SUBJECT: Provides follow-up advisory of defect in double pole torque switch.List of nuclear utility customers,encl.

SUBJECT: Follow-up advisory for 10 CFR Part 21 defect  
reported by American Electric Power

REFERENCE: Donald C. Cook Plant, Units 1 and 2  
Docket Numbers 50-315 and 50-316  
Operating Licenses DPR-58 and DPR-74

Figure 1

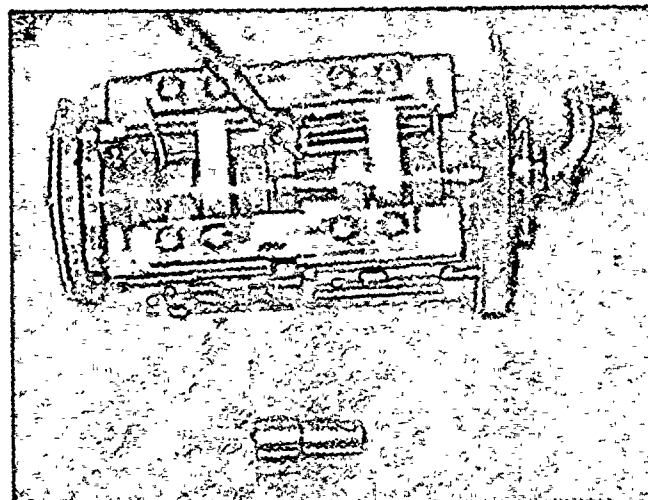
The double pole torque switch shown in Figure 1, installed in SMB, SB, and SBD actuators, has been identified as the defective basic component.

The defective assemblies are missing a spacer between the torque switches, shown in Figure 2 and shown below the double pole torque switch in Figure 1. The affected switch is the outboard assembly (i.e. the switch furthest from the lever arm). The torque switch contacts open prematurely resulting in either incorrect indication of output torque delivered or de-energization of the actuator motor prior to the valve achieving full travel. The aforementioned results are dependent upon the electrical control circuit that is utilized.

Licensee corrective action must include reviewing all installed and in-stock torque switches to determine if any double pole torque switches exist in inventory or are installed. Once identified, the licensee must visually examine each for the presence of the subject spacer, and

replace any torque switches which are missing the spacer. Defective torque switches may be returned to Limatorque for repair and replacement. The Limatorque contact for returns is Jim Hammer, Product Reliability Manager, at Ext. 9863.

Figure 2

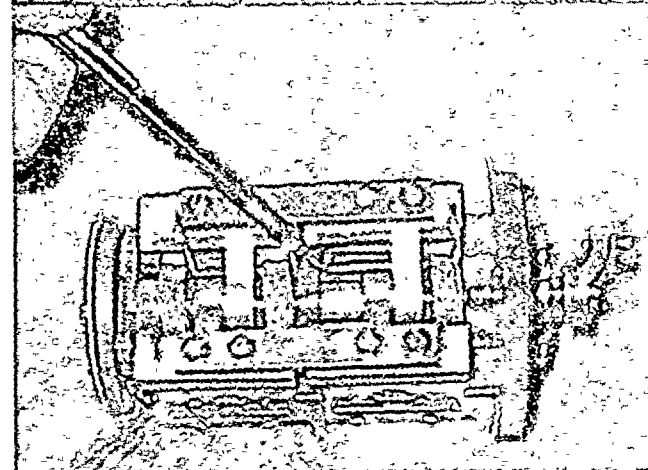
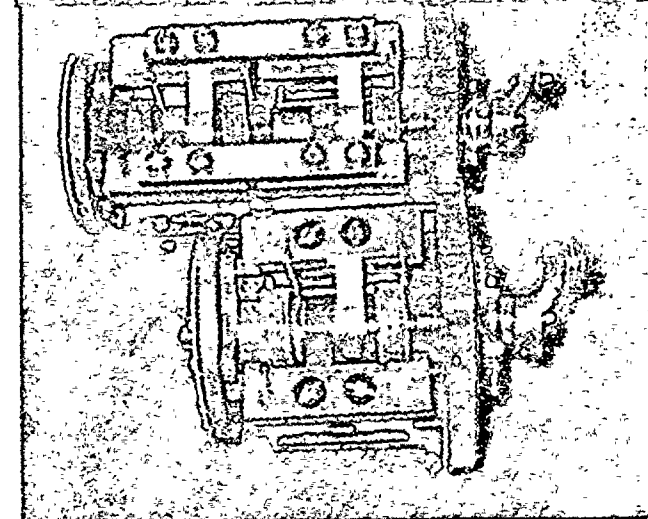
*NOTE: The above part numbers may not be applicable for Double Pole Torque Switches procured for actuators manufactured prior to 1975. In this case, Figure 2, can be used for visual identification of the torque switch.*
